## CITY OF ALEXANDRIA Project Implementation

# Waterfront Flood Mitigation Project Discussion

June 23, 2025

# AWA Alternative Concept

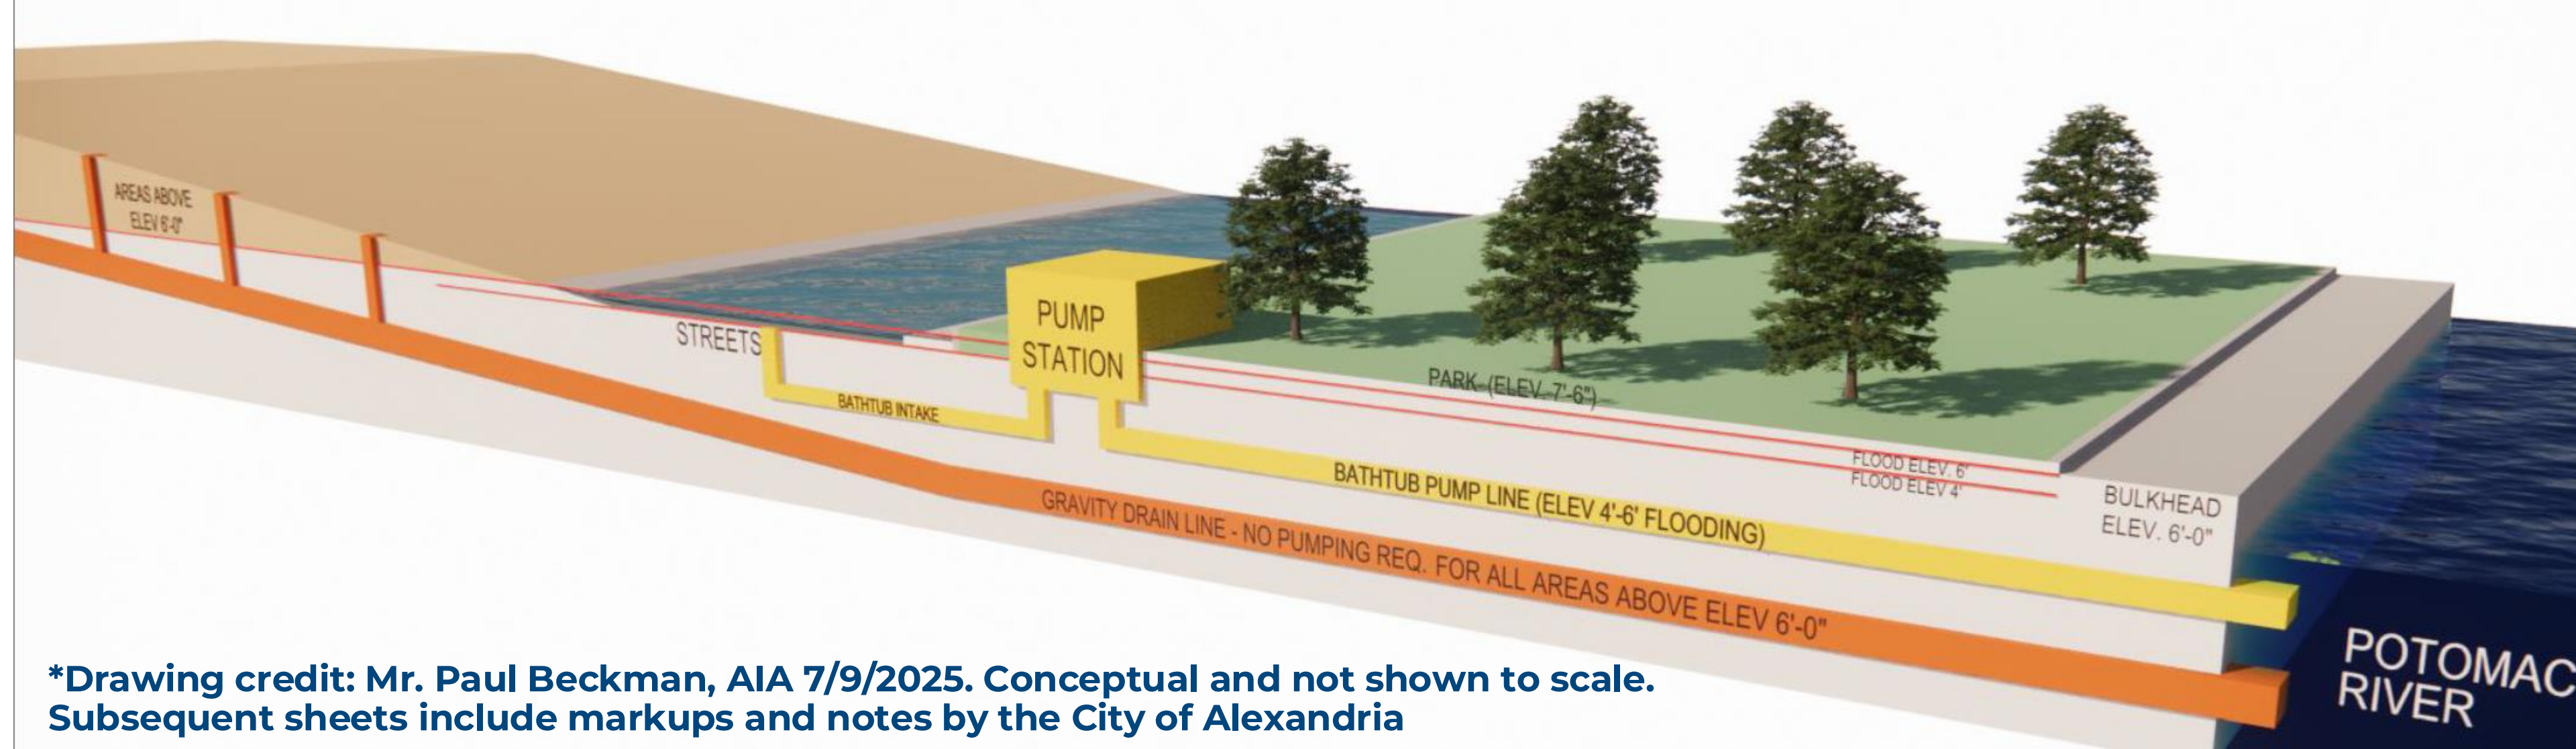
This theoretical concept proposes a dual stormwater system which, after evaluation by engineering analysis and modeling:

- **Does not substantially reduce the footprint/size of the pump station**
- **Increases construction impacts as compared to the City's current proposal:**
  - Would require deep excavations and deeper outfall structures than is feasible/sustainable
  - Would still requires phased street closures
  - Would likely increase utility conflicts and disruption due to relocations
  - Would likely increase construction impacts to residential areas and park areas (including Founder's Park)
- **May increase overall project and construction costs**

## Waterfront Park Pump Station

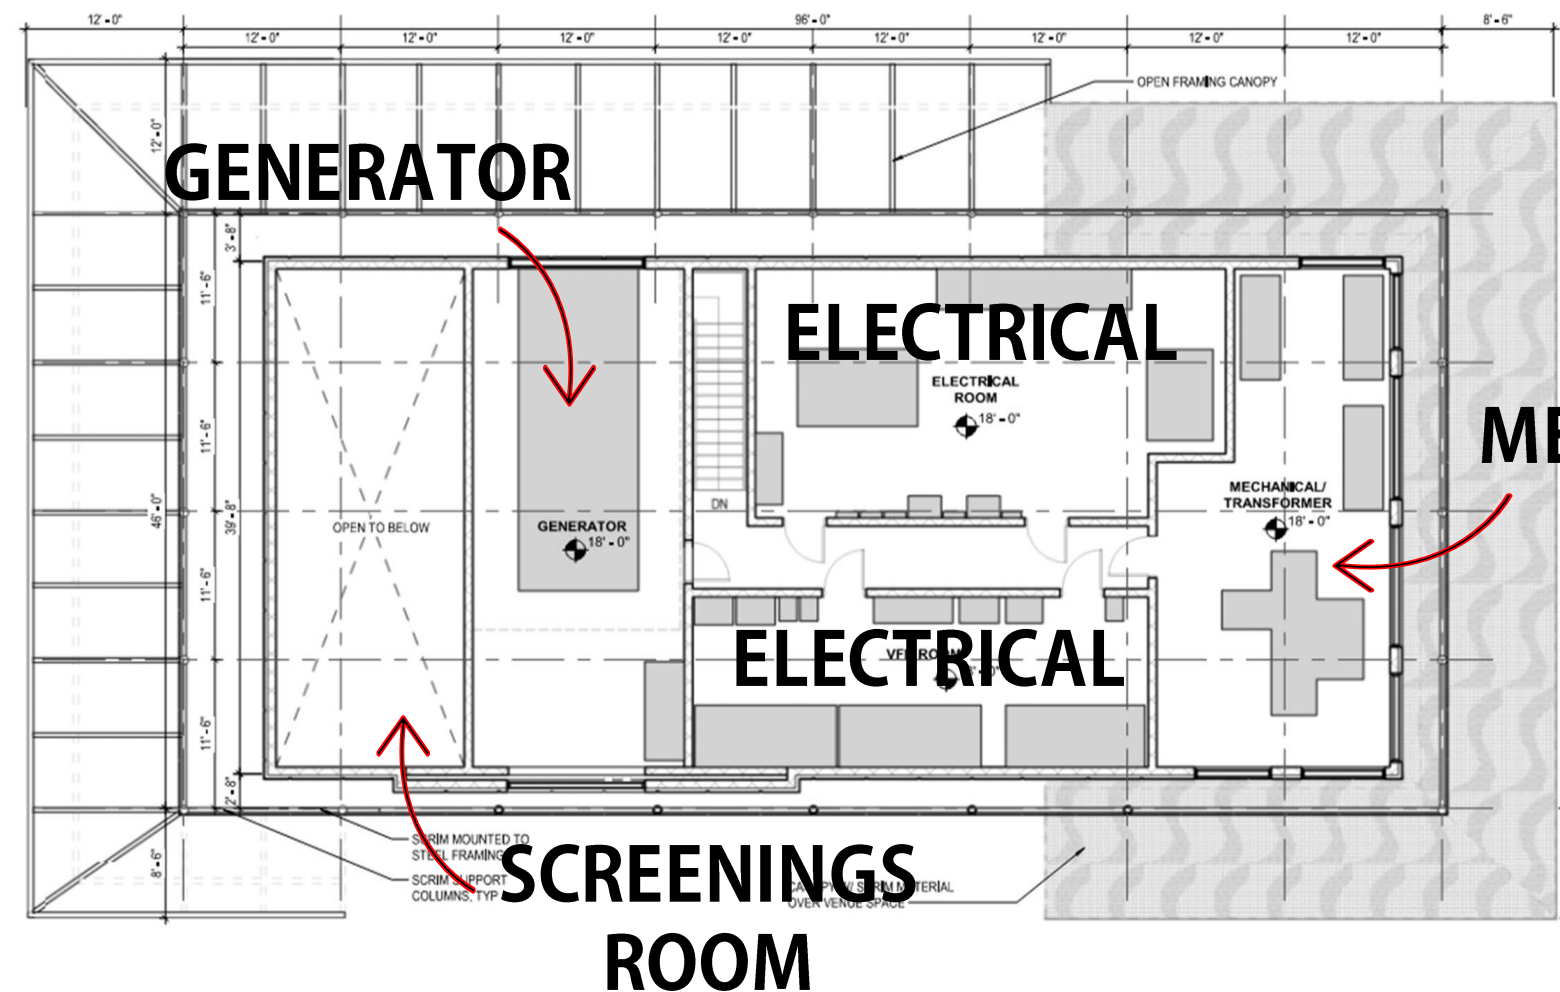
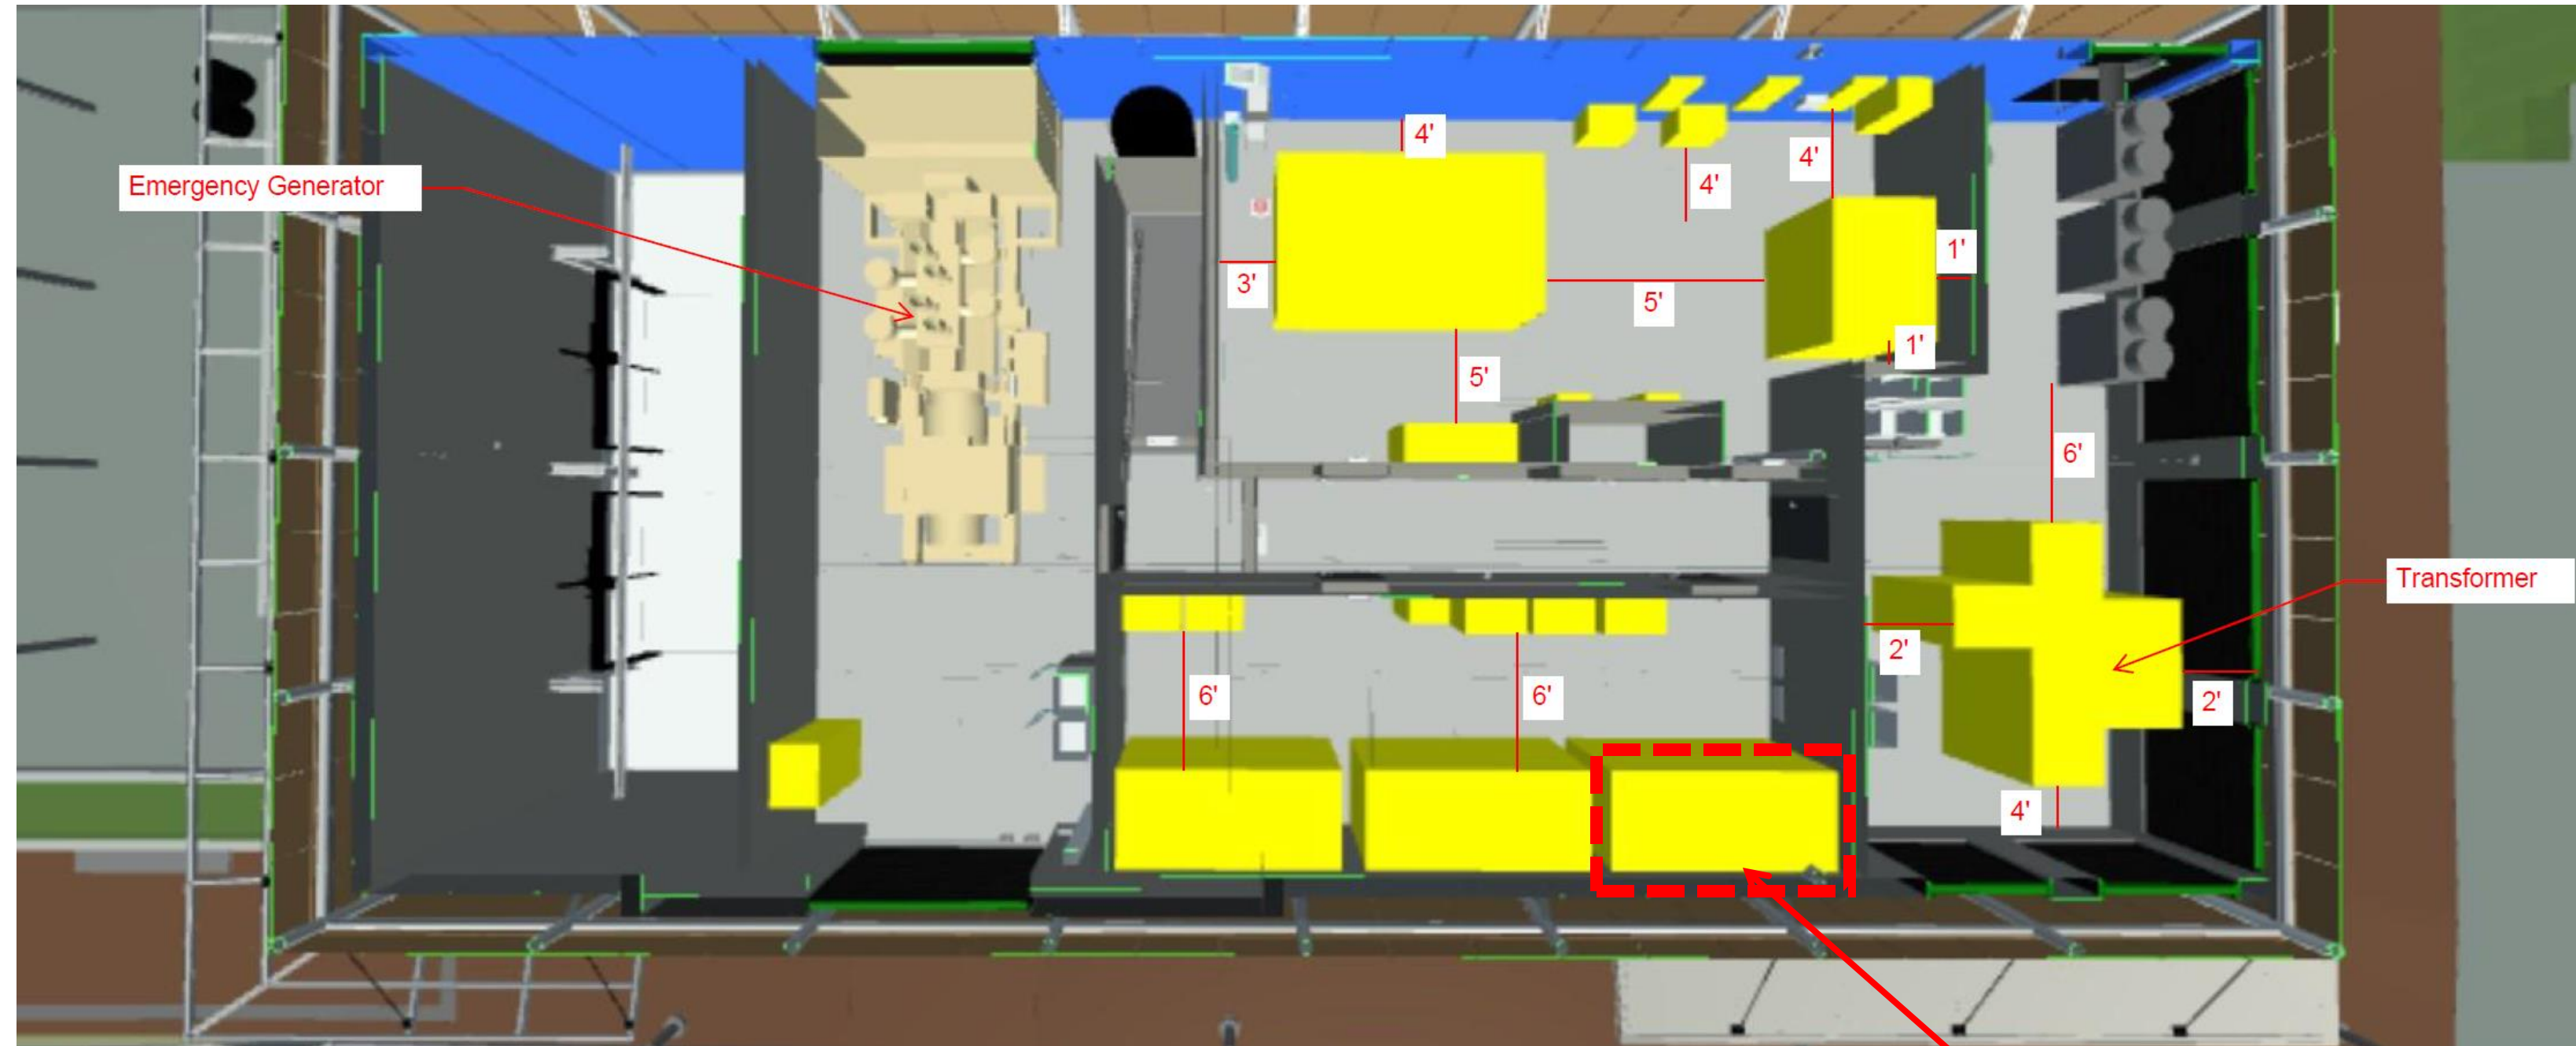
The Pump Station footprint is approx. 96' x 46' (4,420 SF).

On the lower level, the footprint includes a covered plaza supporting a portion of the second story.

The second floor sets the building footprint.

These rooms are fundamental to the operation of any pump station, regardless of flow/capacity.

# Impacts of AWA Alternate Concept

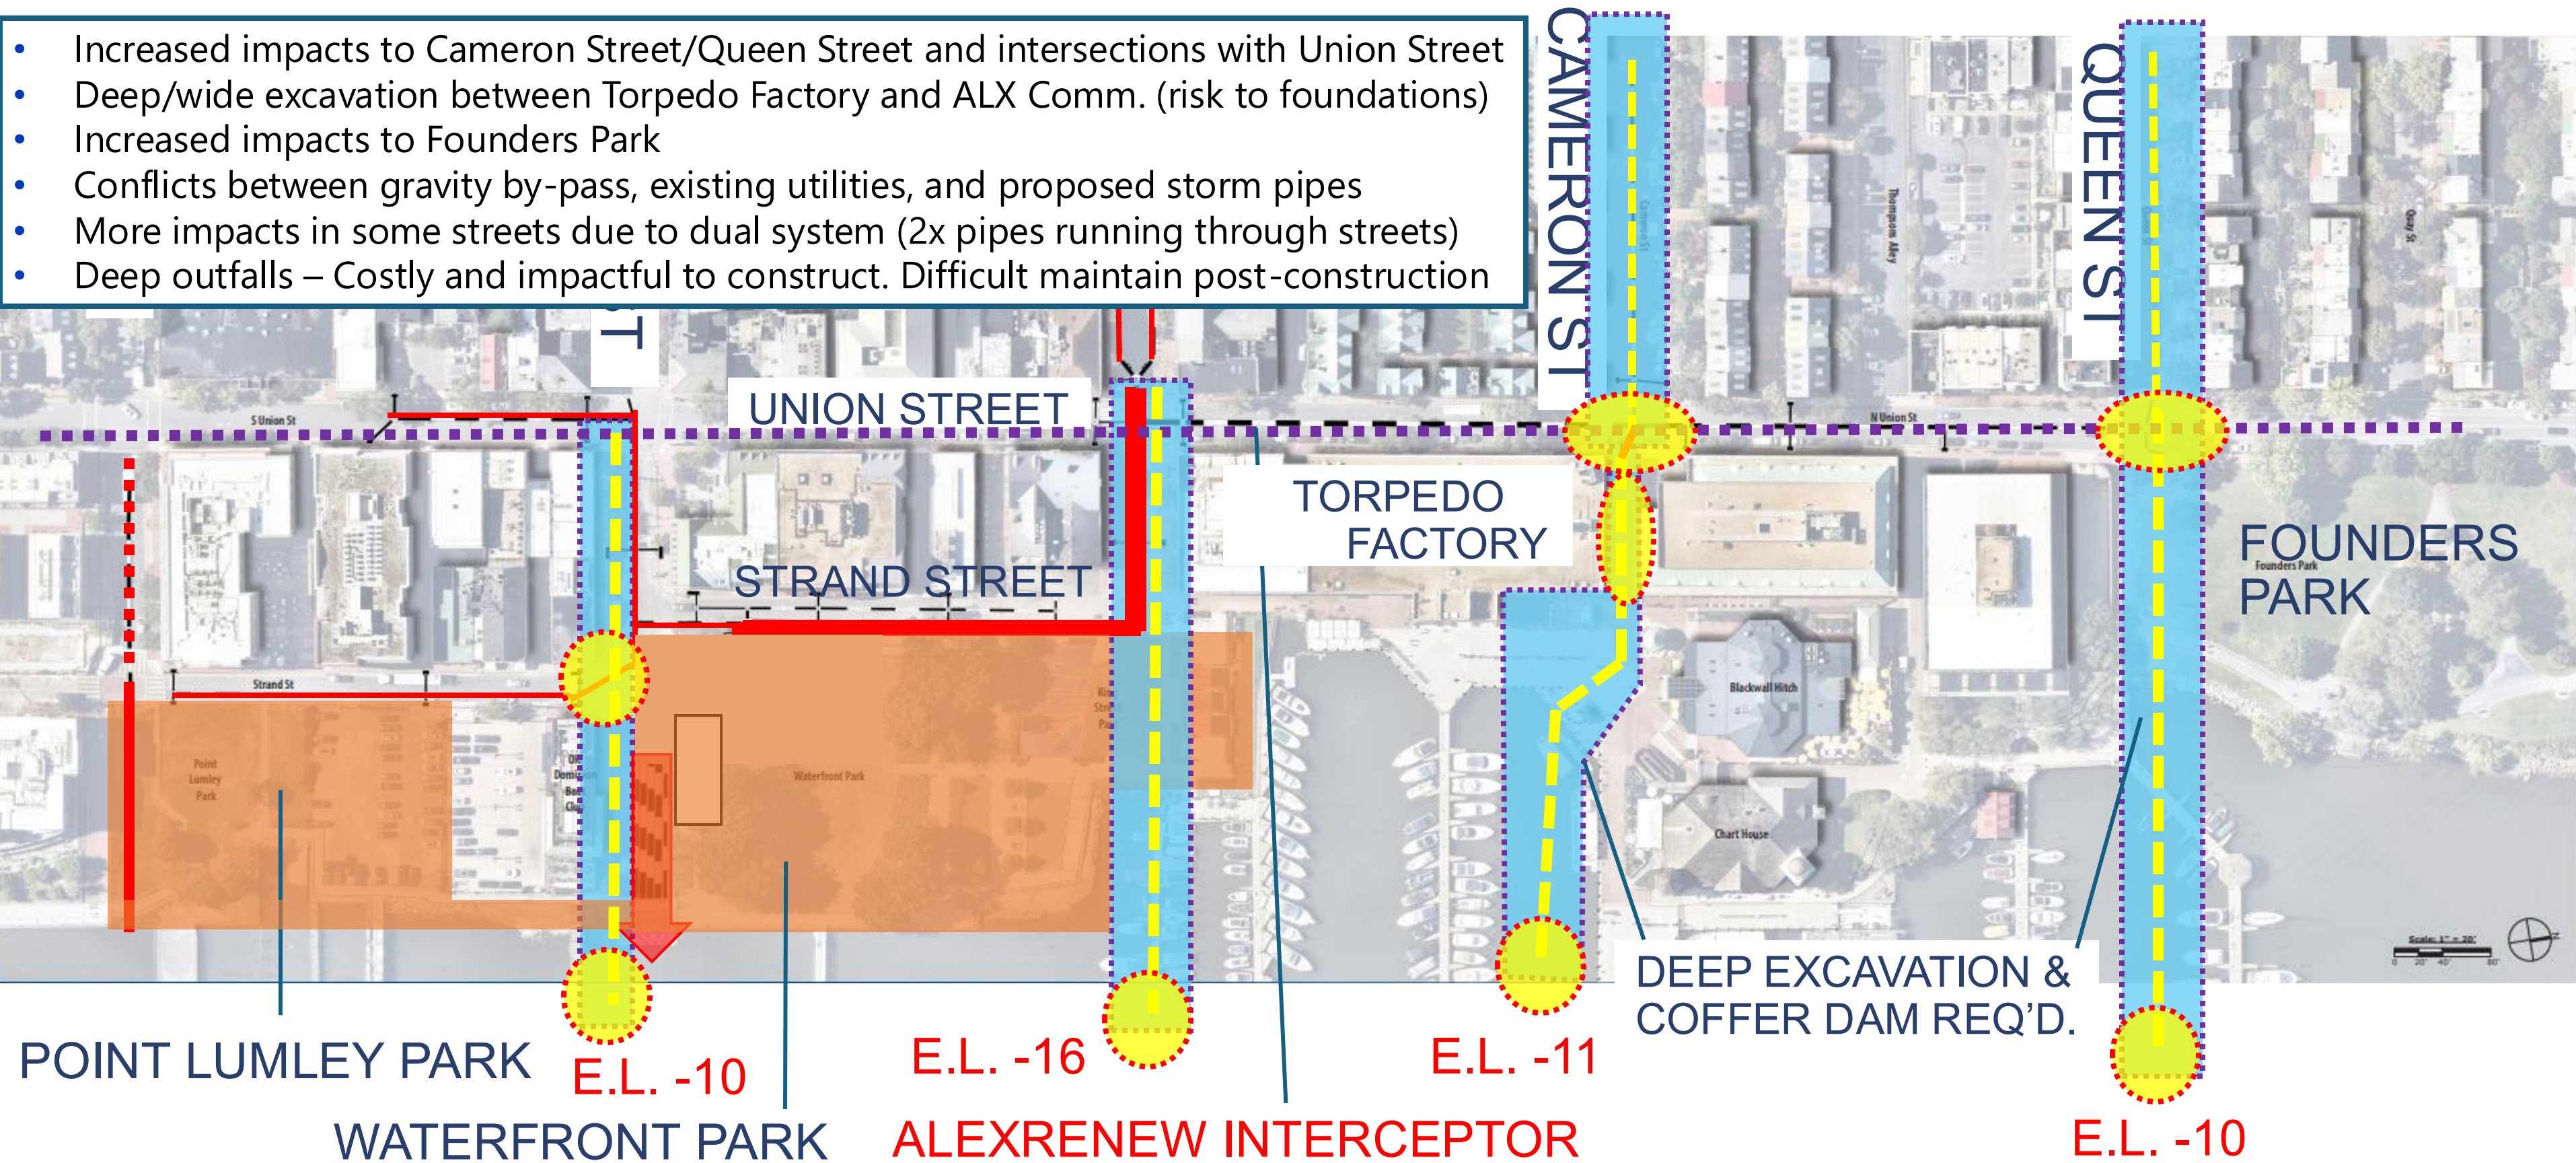
This approach would be more impactful than the City's proposal.  
Would still require deep excavation, long-term street closures, and additional impacts to street ends and park areas (including Founder's Park)

- Increased impacts to Cameron Street/Queen Street and intersections with Union Street
- Deep/wide excavation between Torpedo Factory and ALX Comm. (risk to foundations)
- Increased impacts to Founders Park
- Conflicts between gravity by-pass, existing utilities, and proposed storm pipes
- More impacts in some streets due to dual system (2x pipes running through streets)
- Deep outfalls – Costly and impactful to construct. Difficult maintain post-construction
